Access Compliance Report

Public Rights-of-Way

(Curb Ramps)

Intersection ID: 52487	Main Street: WHITEHALL_EXECUTIVE_CENTER_DR	Cross Street: ORLICK_DR	Location: W
ADA ID: BCCBAFB19F4D	Ramp Type: Perp	Initial Pass/Fail: Fail	Overall Compliance: No
Severity Score: 12.5			
Codes/Mitigation Info/Possible Solution		Field Measurements/Component Compliance

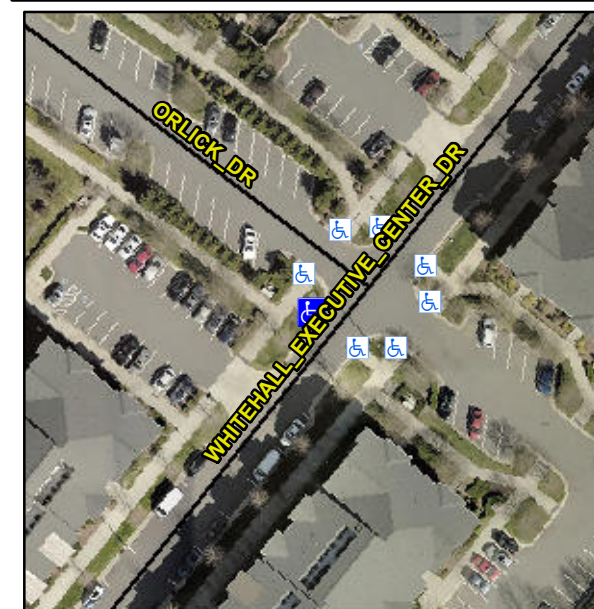
Compliance	Description	Data	Compliance	Description	Data
N/A	Ramp Length (in)	81.0	No	Ramp Slope (%)	8.8
Yes	Ramp Width (in)	71.0	Yes	Ramp XSlope (%)	1.4
N/A	Flare Type LT	N/A	N/A	Flare Type RT	N/A
N/A	Flare Slope LT (%)	N/A	N/A	Flare Slope RT (%)	N/A
N/A	Flare Traversable LT?	N/A	N/A	Flare Traversable RT?	N/A
N/A	Landing Length (in)	N/A	N/A	DWS Provided?	N/A
N/A	Landing Width (in)	N/A	N/A	DWS Contrast?	N/A
N/A	Landing Slope (%)	N/A	N/A	DWS Length (in)	N/A
N/A	Landing X Slope (%)	N/A	N/A	DWS Full Width?	N/A
N/A	Landing Curb? (Y/N)	N/A	N/A	DWS Offset (in)	N/A
N/A	Shared Landing?	N/A			
N/A	Gutter Ponding?	N/A	N/A	Gutter Slope (%)	N/A
N/A	Gutter Lip Ht (in)	N/A	N/A	Gutter X Slope (%)	N/A
N/A	Painted X Walk1?	No	N/A	Painted X Walk2?	N/A
	X Walk 1 Direction	To SE		X Walk 2 Direction	N/A
N/A	X Walk 1 Width (in)	N/A	N/A	X Walk 2 Width (in)	N/A
	X Walk 1 Slope (%)	1.0		X Walk 2 Slope (%)	N/A
	X Walk 1 X Slope (%)	0.4		X Walk 2 X Slope (%)	N/A

Remove & Replace Entire Ramp.
